TECHNICAL BULLETIN

No: JTB00191
Issue: 1
Date: 17 MAY 2010

Glove Compartment Lid not Damped When Opening

XK (X150)

Figure 1

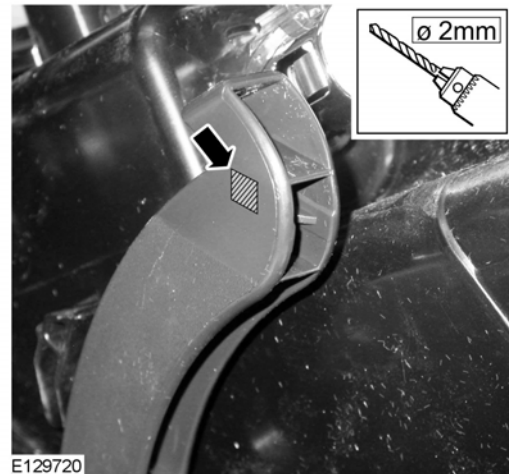
1. Refer to Workshop Manual (GTR) section 501-12 and remove the glove compartment.
2. Drill a 2mm hole through the glove compartment damper arm (shaded area, Figure 1).

Figure 2

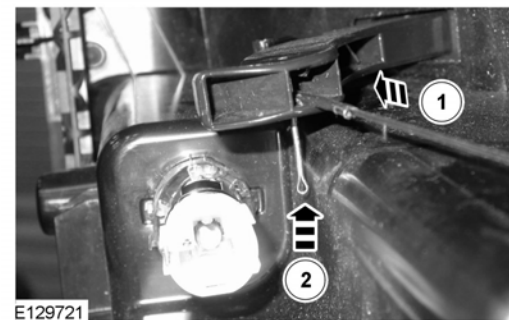
3. Install the glove compartment lid damper cord looped end into the damper arm. (① in Figure 2)
4. Install the split / cotter pin into the hole and through the damper cord looped end. (② in Figure 2)
